**RR/2019/840/P Outline: Development of 6 dwellings (Amended)  
Ferry Road - Land at, Rye TN31 7DJ**

On behalf of Rye Conservation Society, I am writing to restate our objection to the above application for the following reasons.

Proposed Elevation of House 1 and Street scene.

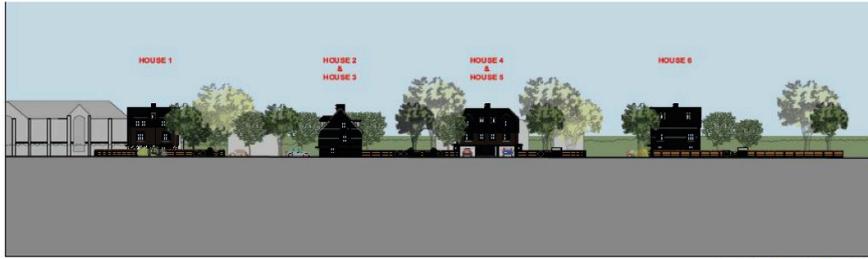
The scale of the proposed houses is as shown below.

What is apparent from the above is that the scale of the proposed units is NOT 2.5 storeys as described in the Design and Access Statement but a full 3 storeys plus roof and relates to the former granary at 48 Ferry Road and not to the surrounding residential streets.
